APPROVED MINUTES OF THE MEETING

November 19, 2009

November 19, 2009 **Project:** **Rainier Beach Community Center**
Phase: Schematic Design
Last Reviewed: September 17, 2009
Presenters: David Graves, Seattle Parks and Recreation
 Stan Lokting, ARC Architects
 Kenichi Nakano, Nakano Associates

Figure 1: Rainier Beach Community Center & Pool plans and renderings

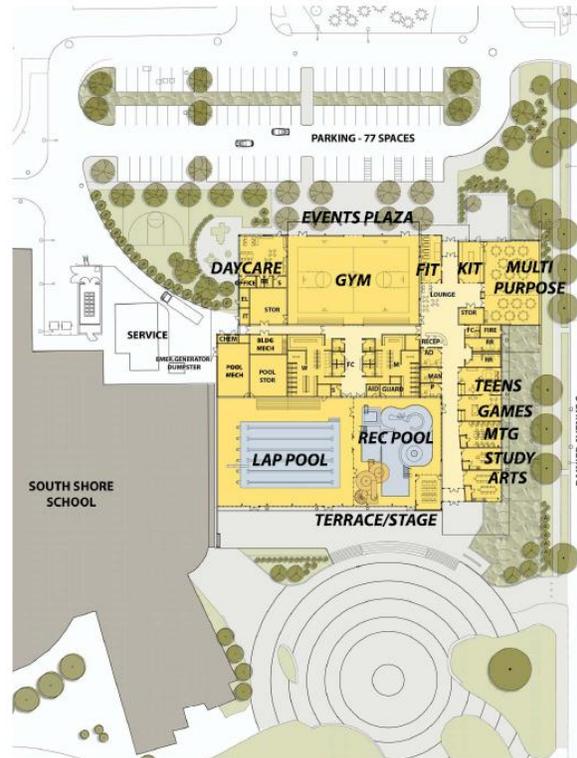
Where are the mechanical systems hidden?

What happened to the buffer strip?

With regards to the structural frames, how will they be presented?

How high off the ground will the green roof be located and what types of plants might be used?

Need to go further with the rigor and discretion of the forms. The party room wall stands out negatively on south elevation.

Handicapped parking hinders use of the events spaces. Is there any flexibility?

Strongest parts of the buildings are the glass walls. The commonality between them is important. Think hard about putting a different structural connection between the different parts of the buildings.

The slot wall is at odds with the rest of the façade. The welcoming entries need to be enhanced.

The roof is a powerful element that could be extended from the south of the building through the north.

We encourage editing. There are many exciting spaces. Privacy wall needs some study. The multi-purpose room location along Rainier might present sound issues.

There is a lot of space in the plaza that could be used for green space.

Moving the basketball court to another location would be helpful.

A pedestrian path for people coming from Rainier would be helpful.

Consider a side path for pedestrians to appreciate the rain gardens.

They are hidden on the roof in a "mechanical farm. There are five rooftop units, two per pool.

They will be located within the glass and will be seen.

The preliminary idea is for intensive vegetation along the edge so that it can be seen from the street level and extensive in center. The minimum height of the green roof from grade is approximately 15.5-feet.

Handicapped spots must be located curbside at main entrance.

An engineer will evaluate the noise.
